CITY OF ALBUQUERQUE

Re: Drainage at 10812 Malaguena Lane NE

TITLE: ACADEMY RIDGE EAST PHASE I
 GRADING PLAN

DRAINAGE REPORT
FOR
ACADEMY RIDGE EAST

DRAINAGE

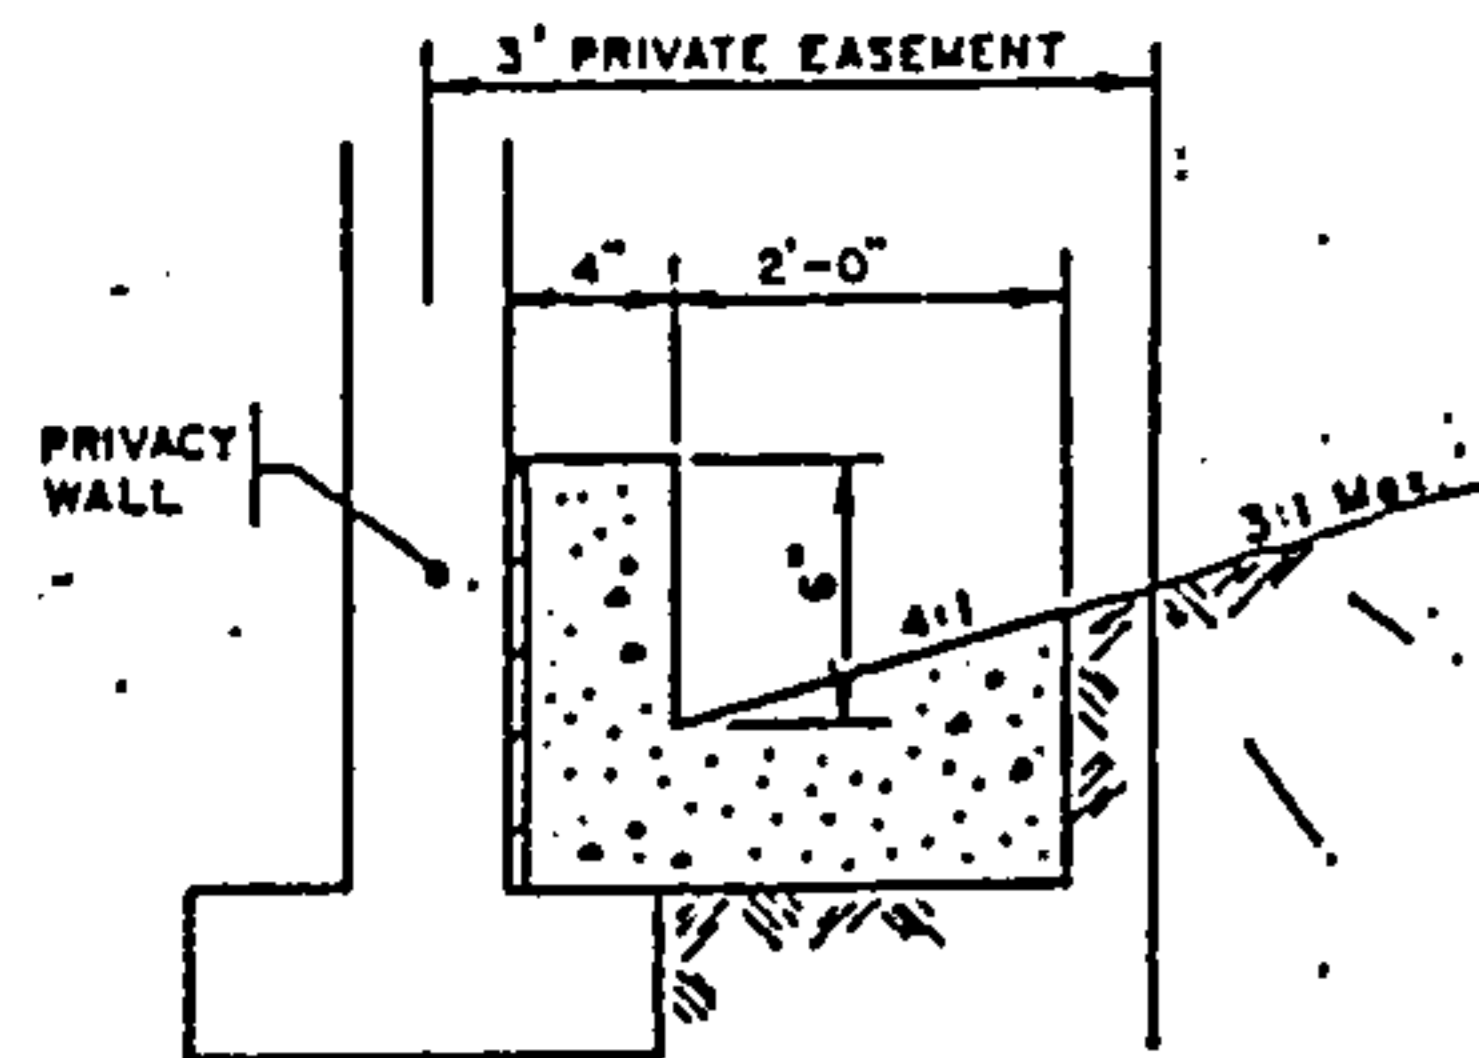
This letter is issued in response to a complaint about recent changes made to your lot (10812 Malaguena Ln. NE) that adversely affect the overall drainage plan for this area. Per the approved grading and drainage plan for the Academy Ridge East Subdivision Phase 1, "rear lot discharges will be collected in a swale type ditch and transmitted from lot to lot through holes built into the block walls between lots. Every sixth lot (counting downstream) will provide a 5 foot private drainage easement and a swale to convey the collected flow to the street." The grading plan for this site designates your lot as a lot that must convey the collected flow to the street. Your changes have blocked this conveyance and have caused flooding problems for your neighbors upstream, possibly making you liable for any damages.

In the spirit of cooperation, I ask that you take the appropriate measures necessary to restore the original drainage flow and alleviate the upstream flooding issues. Please contact me at your earliest convenience at 924-3981 to discuss possible remediation methods or if you have any questions. If you are not the property owner, please contact me.

REAR YARD ALTERNATE PRIVATE DRAINAGE RUNDOWN DETAIL
 NOT TO SCALE

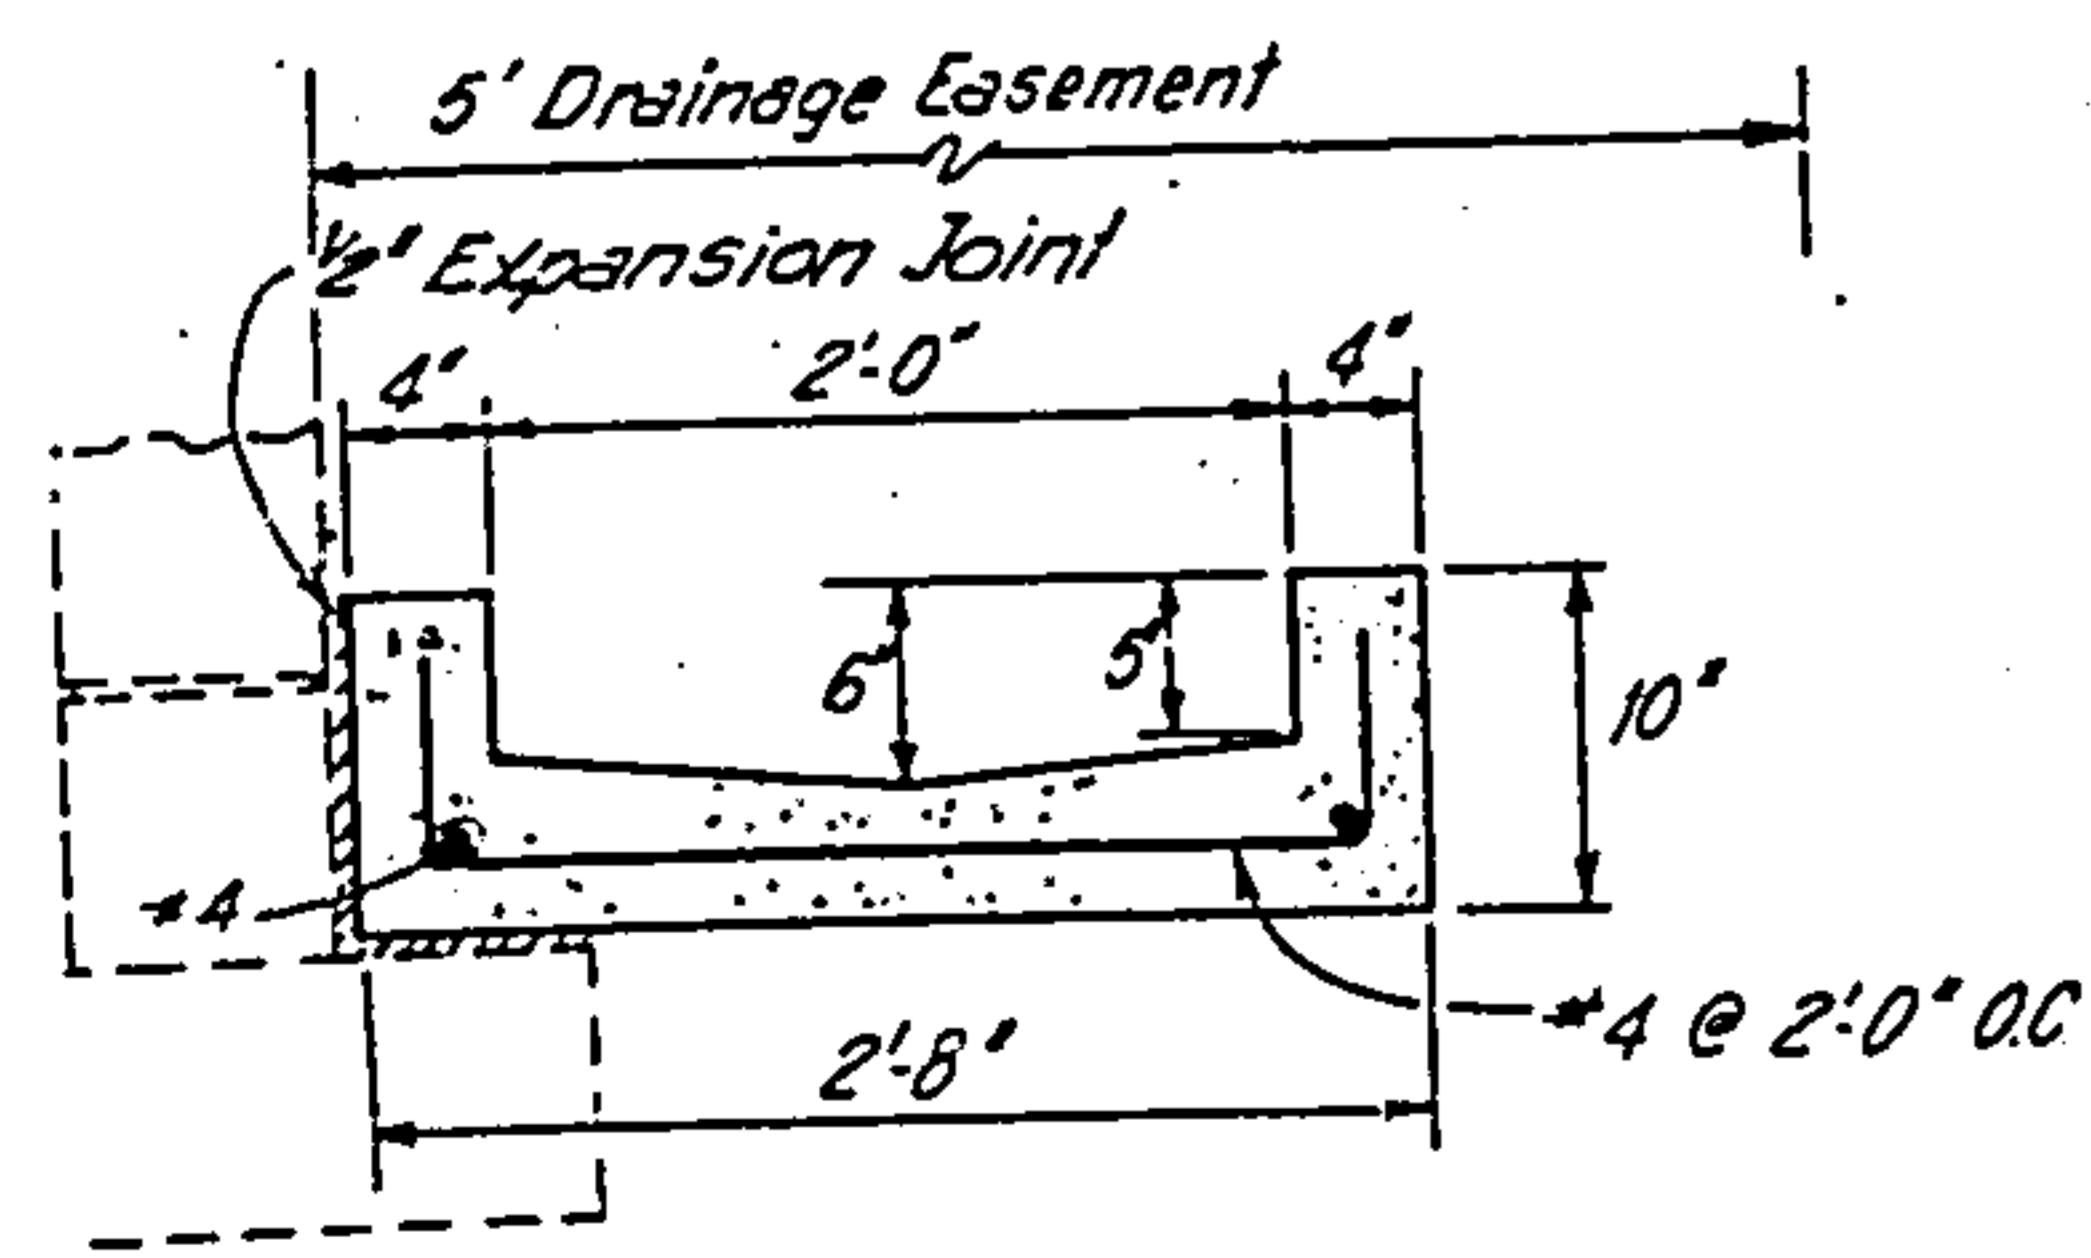
RE: DRAINAGE RUNDOWN MODIFICATION FOR ACADEMY RIDGE EAST, UNIT I
RECEIVED JUNE 24, 1988 FOR BUILDING PERMIT APPROVALS (E-21/D29)
(CITY PROJECT NO. 2289)

The above referenced submittal revised June 23, 1988, is approved. The V-bottom drainage channels may be used where the minimum slope is 0.5%.
